WORLD WAR II MEMORIAL: FDR D-DAY PRAYER

PRESENTATION TO THE
COMMISSION OF FINE ARTS
(COMMEMORATIVE FEATURE DETAILS AND REVISIONS)

CFA 20/NOV/23-1

Plaque Text Layout

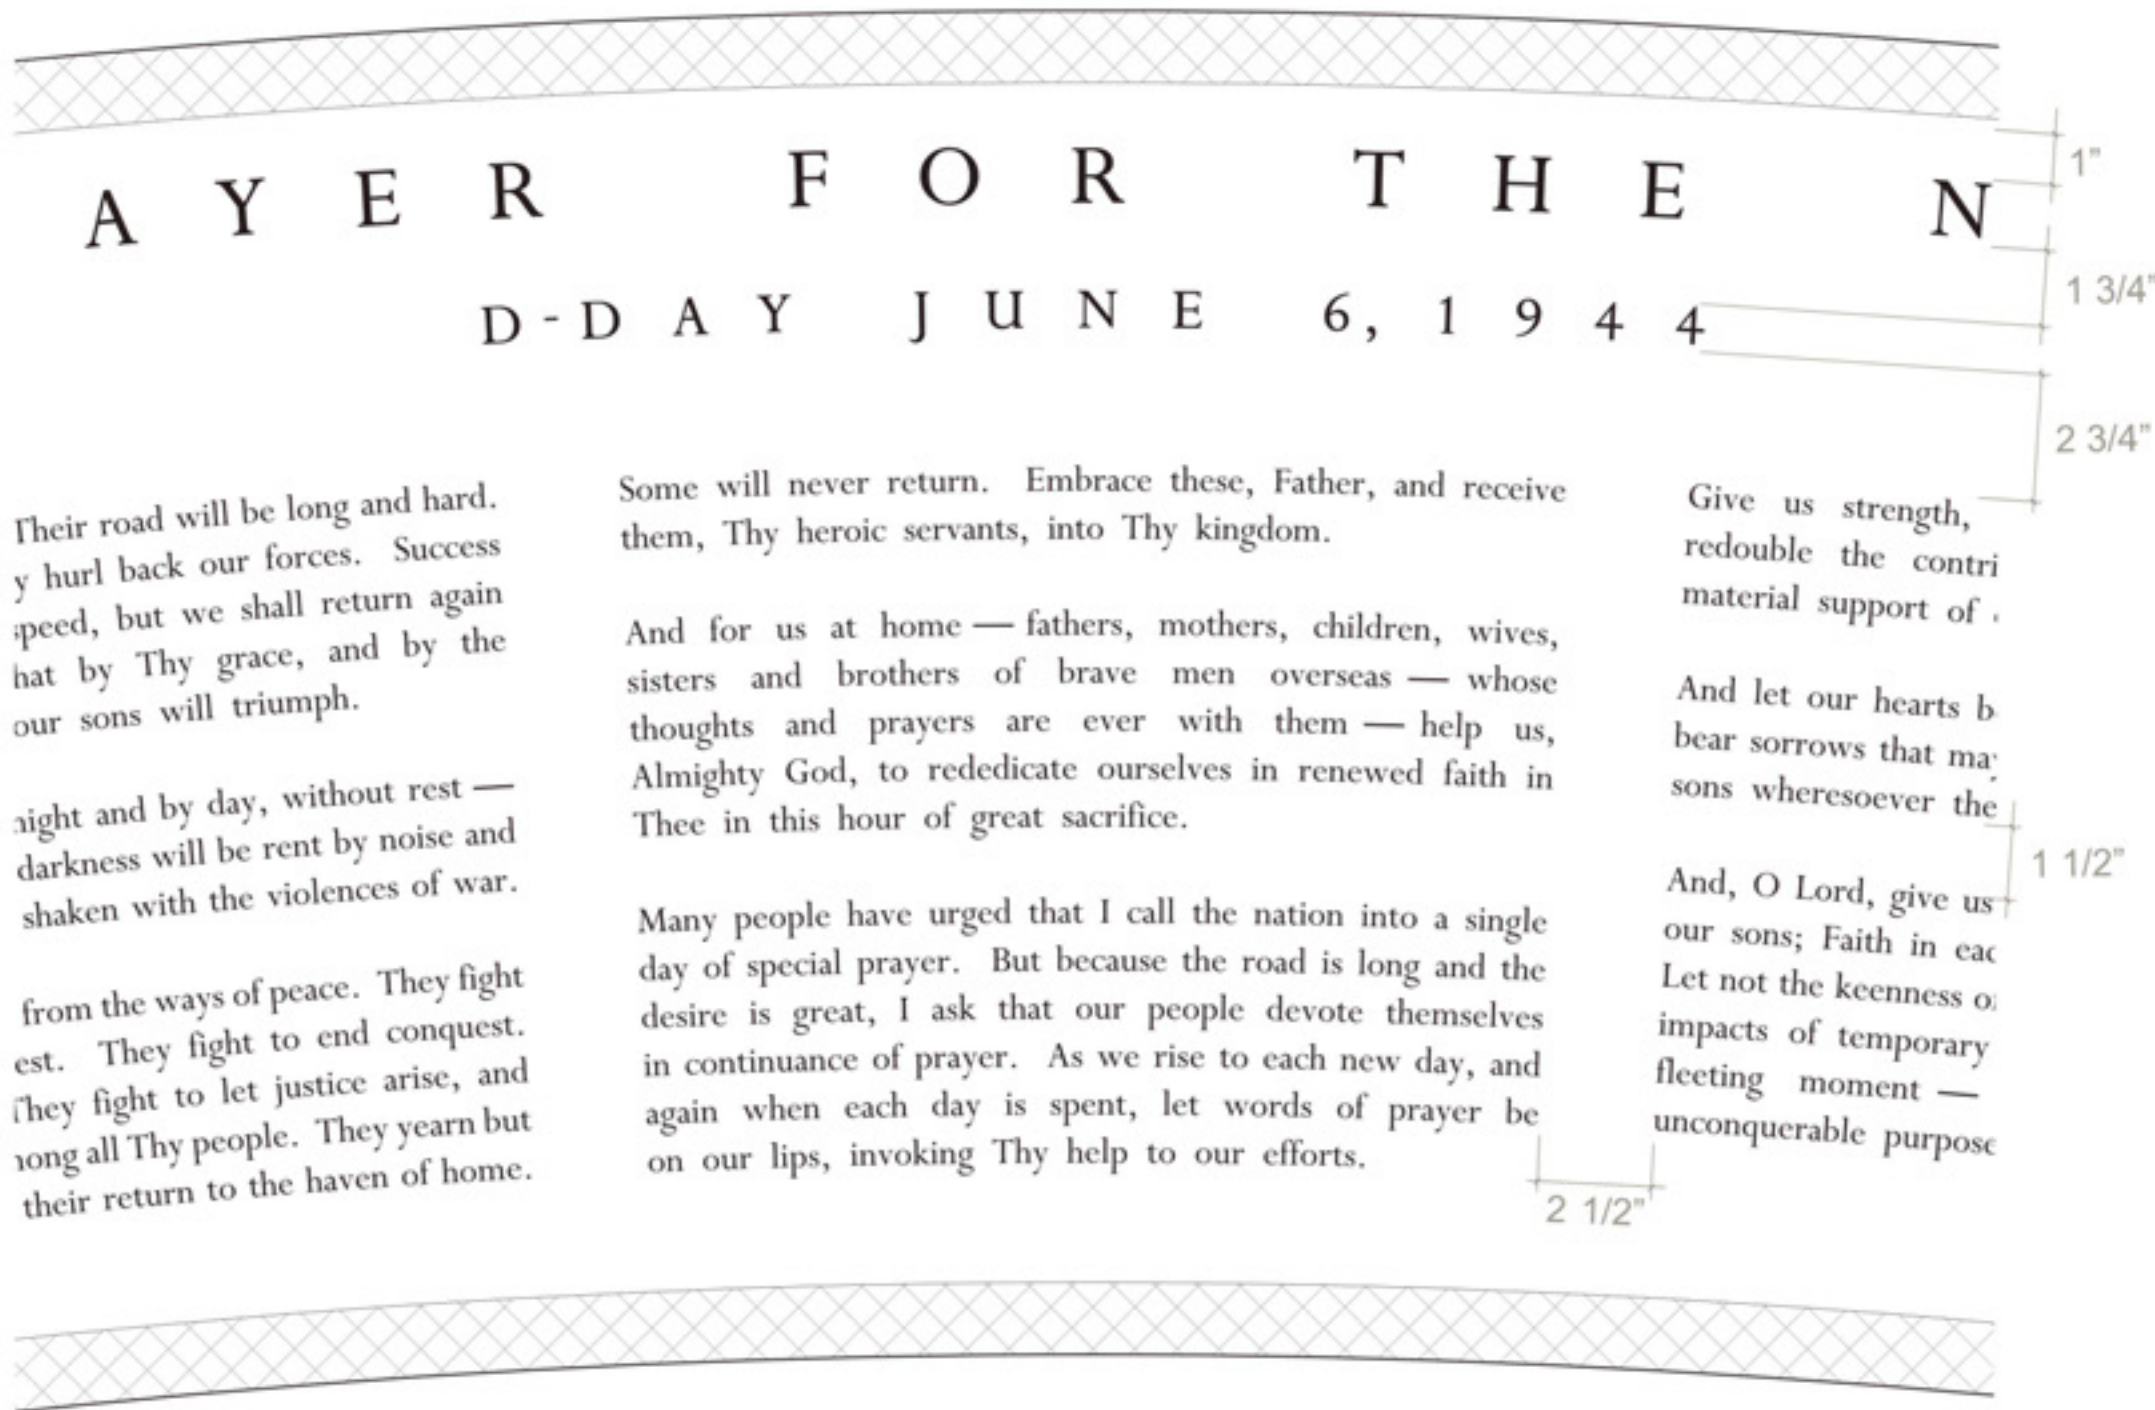
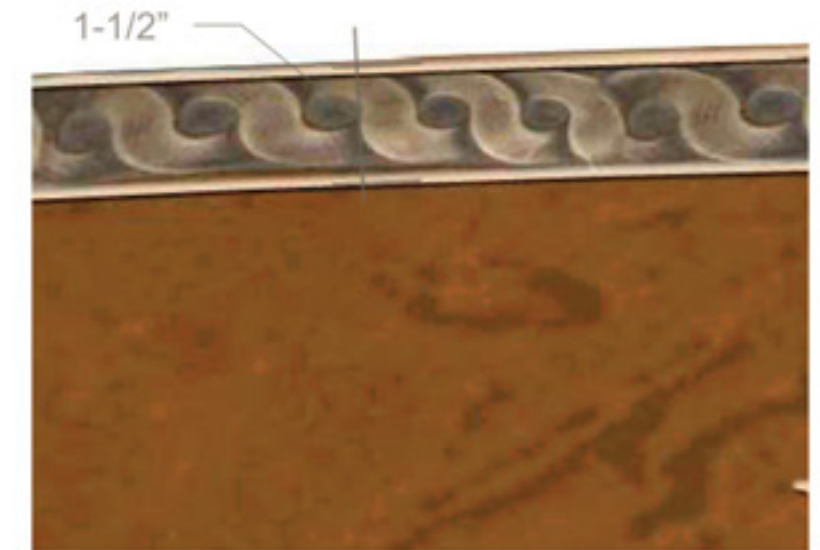
"...the Commission recommended that additional details be developed, [including], the layout of the proposed graphic design for the plaque and **inscriptions.**"

Font for Front Wall and Plaque:
Perpetua

- Complementary to Roman Claudian Variant
- Meets ADA Accessibility Guidelines (ADAAG)
- Meets parameters for casting:
 - Heading
 - 1-1/2 inch
 - Subheading
 - 1 inch
 - Body Text
 - 3/8 inch is minimum text height visible from three feet
 - 25 point kerning (space between letters)
 - 2 pts thick minimum stroke

Entry Text Layout Elevation

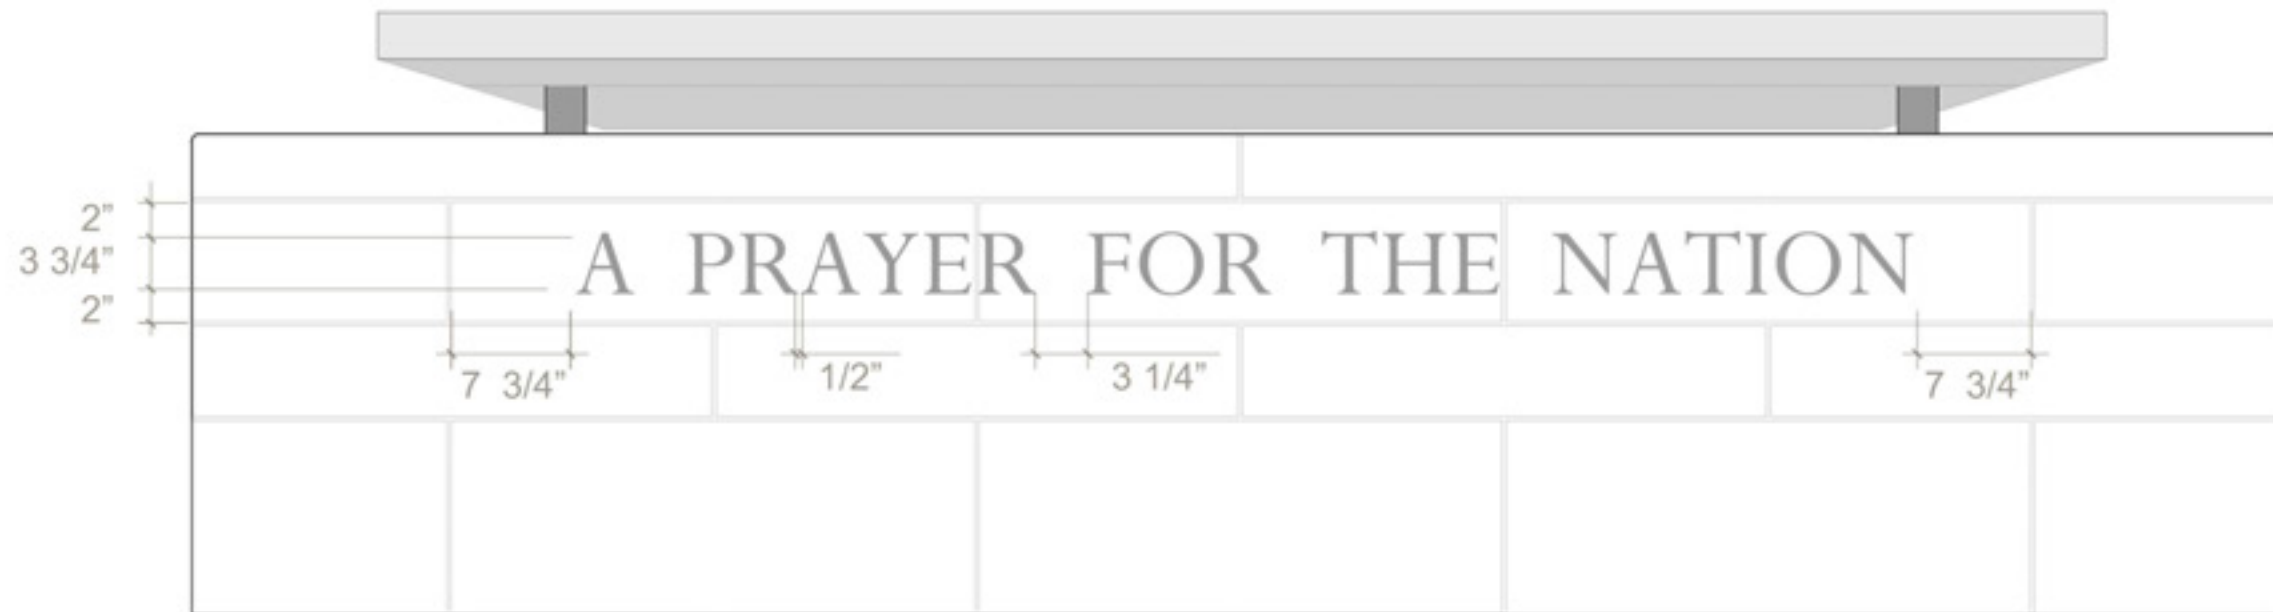
"...the Commission recommended that additional details be developed, [including], the layout of the proposed graphic design for the plaque and **inscriptions.**"

Font for Front Wall and Plaque:
Perpetua

Wall Coursing: Interior Elevation

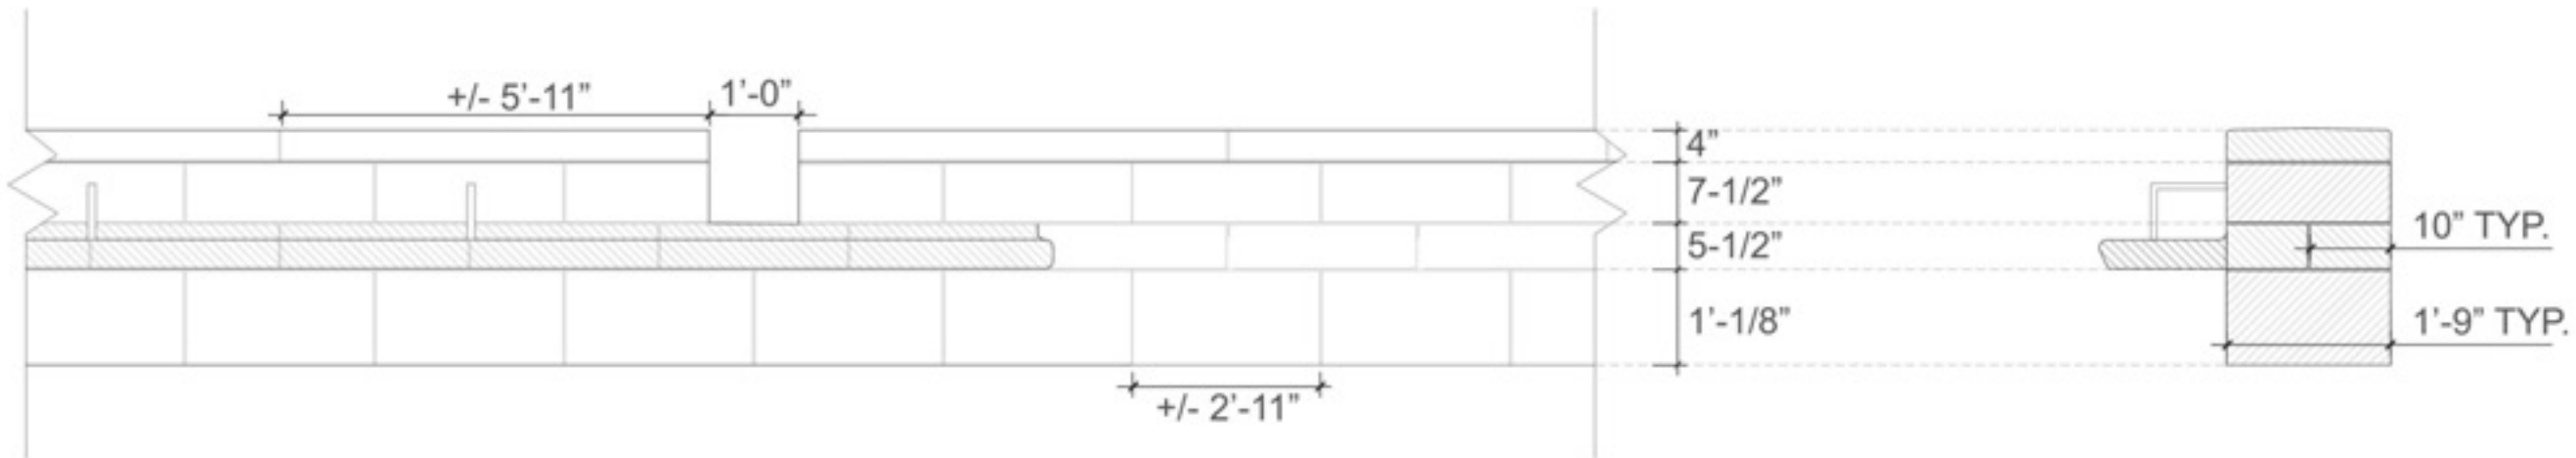
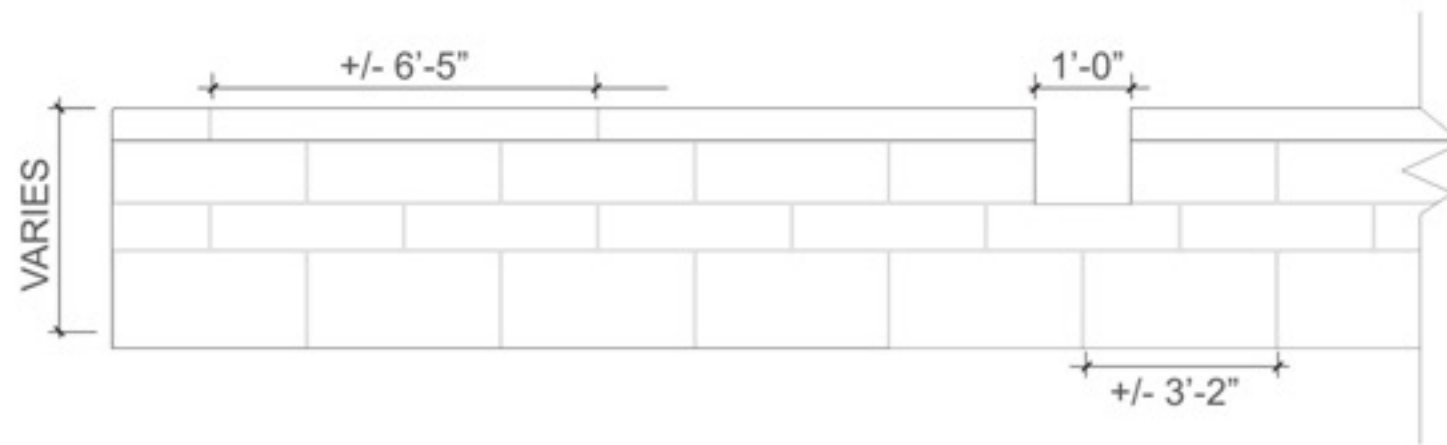
- finalize coursing at ends of freestanding walls

- Wall incorporates (3) stone bands, with center band corresponding to bench
- Bench profile draws from simplified WWII bench design
- Armrests centered on stone veneer
